Bioventing at
Operable Units 5, 8, 9, 10, and 11

Loring Air Force Base
SEMIANNUAL PERFORMANCE REPORT
August — December 1997

March 1998
Revision B

Loring Air Force Base
Comments/Responses
Draft (Revision A) Bioventing Semiannual Report - Second Half 1997
January 1998

Figure 5-1
BXSS Biovent System Layout
and Average Wellhead Flow

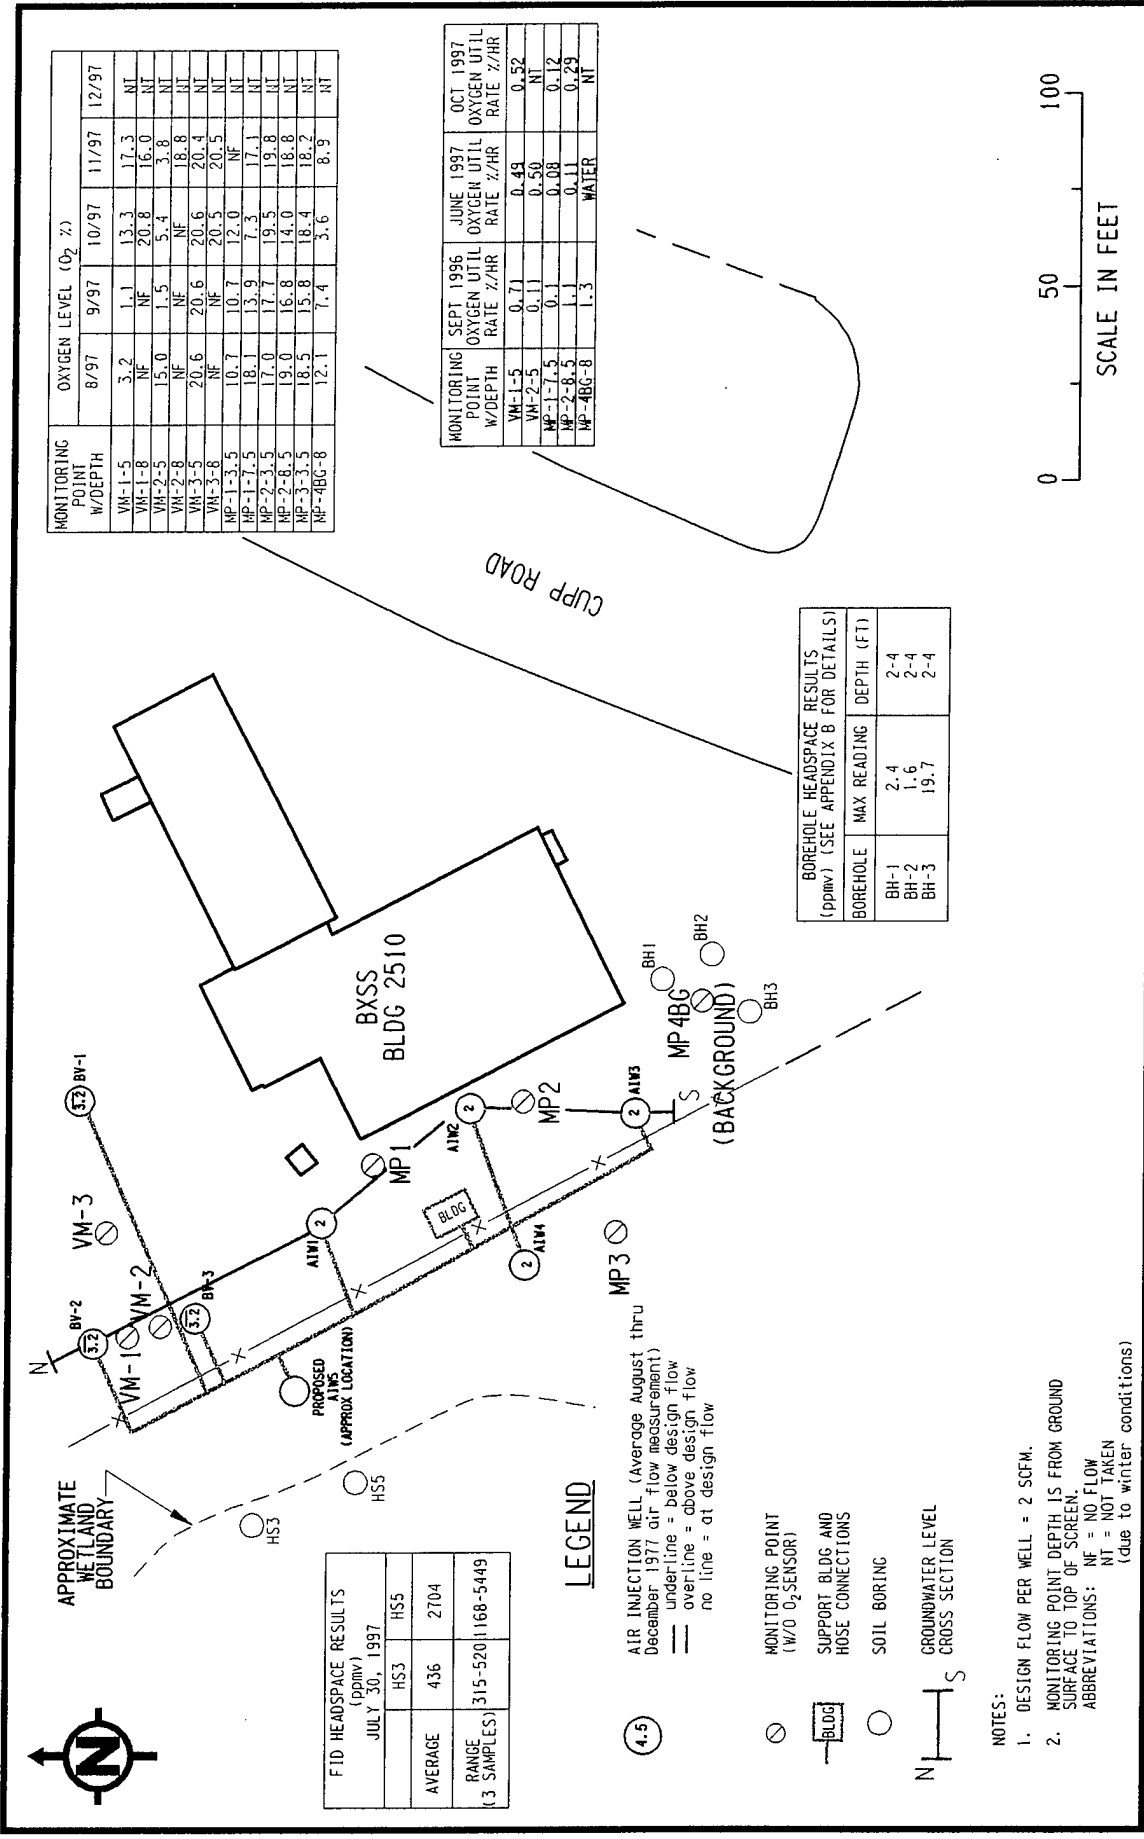
Comments	Response
<p><i>Item 7. Section 5:</i> According to Figure 5-1, there is low oxygen in MP-4BG-8 along with a high respiration rate in 1996. Although the nearby borings and jar headspace readings taken in 1997 revealed low VOCs, there is room to argue that the borings did not advance deeply enough to delineate the subsurface petroleum contamination. I recommend this area be included in the confirmation sampling program and an additional injection well be planned for this area if bioventing is to continue at this site.</p>	<p>The paragraph has been modified to identify the background area as a confirmation sampling site including a sampling depth interval below the depth of MP-4BG (8.5 ft). The soil gas samples were collected to a depth of 10 ft bgs. Wet conditions were noted in the 8 - 10 ft bgs samples therefore the borings were halted since headspace analysis is not effective in saturated soils.</p>

Figure 6-1
ES Biovent System Layout
and Average Wellhead Flow

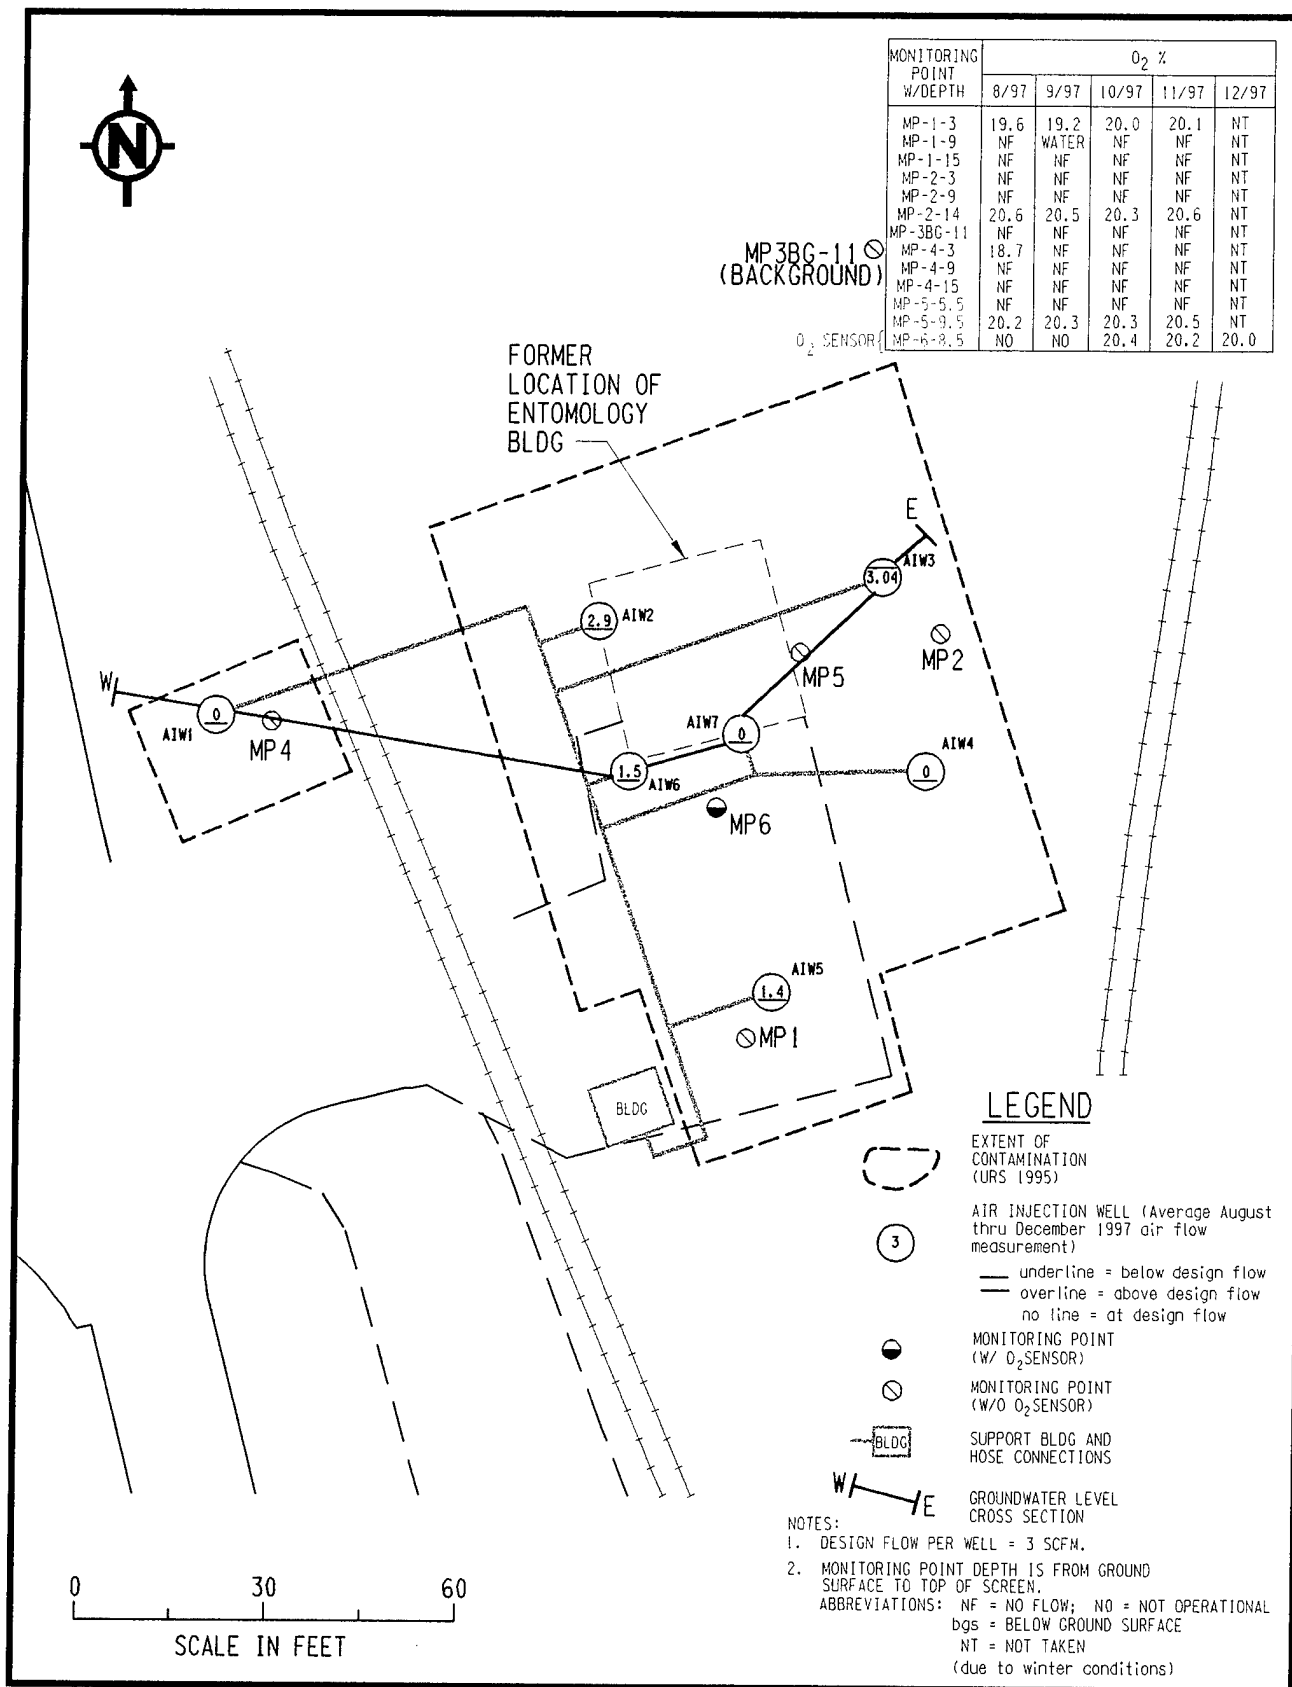
<p><i>Item 8. Section 6, Figure 6-1:</i> The circle for AIW 5 should be underlined.</p>	<p>Good eye. AIW 5 has been underlined.</p>
<p><i>Item 9. Section 6.2:</i> Are we not actually referring to soils rather than sediment at MP-1, MP-4, and MP-2?</p>	<p>Comment incorporated.</p>
<p><i>Item 10. Section 6.2:</i> I agree with the recommendation. Please delete the phrase "risk assessment" which is used to describe the no action alternative. The last sentence should be rewritten. If soil sampling indicates PRGs have been achieved at the site, the bioventing system should be shut down.</p>	<p>Comments incorporated.</p>
